Millstone Nuclear Power Station, Unit No. 2
Response to a Request for Additional Information
Technical Specifications Change Request (TSCR) 2-10-01
Fuel Pool Requirements

Millstone Nuclear Power Station, Unit No. 2
Response to a Request for Additional Information
Technical Specifications Change Request (TSCR) 2-10-01
Fuel Pool Requirements

FIGURE 1 MILLSTONE 2 SFP SILICA VS. TIME

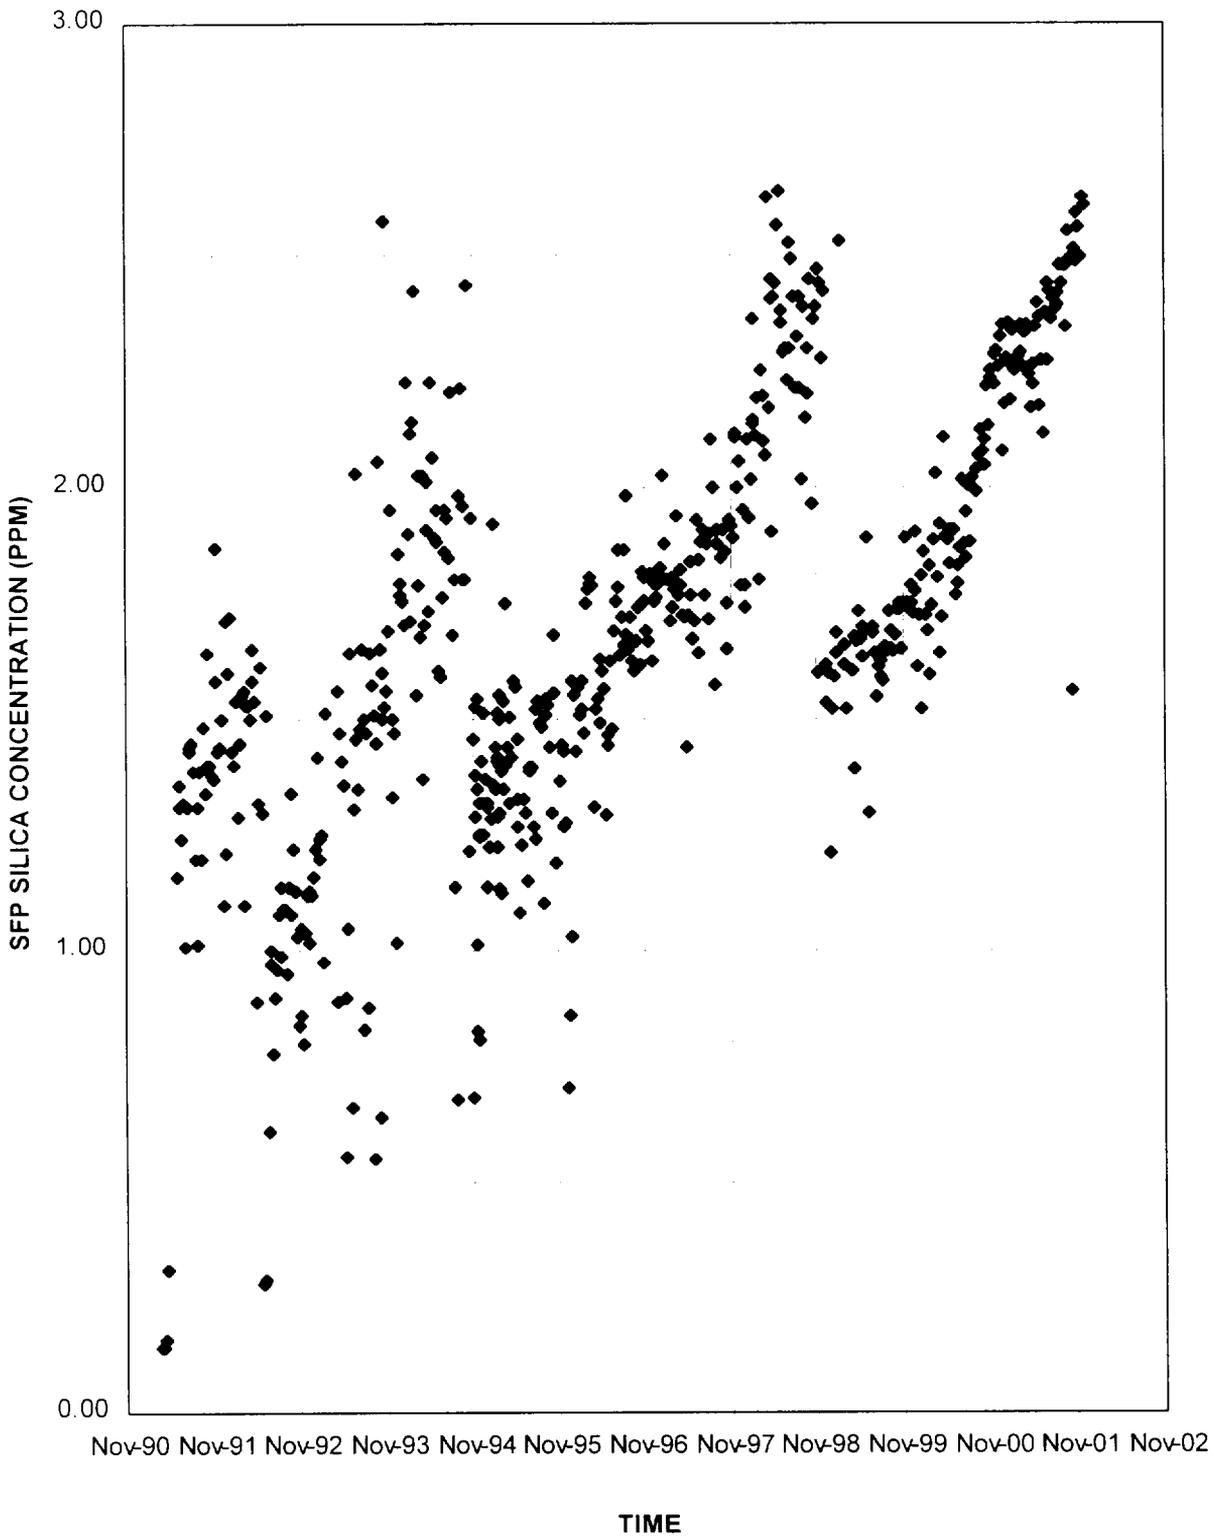
- b. Does the licensee have plans to perform additional blackness testing prior to and after adding spent fuel to Regions A and B?
- c. The licensee's submittal states that spent fuel pool silica concentrations are measured and monitored for any unusual trend. Using the silica concentration can help determine the average boraflex loss but will not identify the most degraded panel. What is the licensee's method of accurately determining boraflex degradation (e.g., BADGER testing)?

First, the EPRI RACKLIFE computer program is used to predict the level of degradation in each of the boraflex panels in the Millstone Unit No. 2 spent fuel pool. The RACKLIFE computer program calculates the integrated gamma dose to each boraflex panel by tracking individual fuel assembly residence time and burnup history in each storage location. Knowing the gamma dose to each boraflex panel, the spent fuel pool silica measurements, cleanup system parameters, various other water chemistry parameters and rack and pool characteristics, RACKLIFE calculates the projected amount of degradation to each boraflex panel. The RACKLIFE model is updated at regular intervals. The attached Figure 1 shows the Millstone Unit No. 2 spent fuel pool silica measurements over the last decade, with each diamond on Figure 1 representing 1 silica measurement. As can be seen from Figure 1, the measurements have generally been between 1-3 PPM silica over the last 10 years. The Millstone Unit No. 2 racks have been in service for about 15 years, and silica levels this low imply minimal boraflex degradation. The RACKLIFE model results show the average boraflex panel is reduced in Boron-10 density by a value of about 0.8%, with a peak value in the worst boraflex panel of about 0.9%. These are very low predicted boraflex degradation levels, consistent with (and driven by) the observed silica measurements.
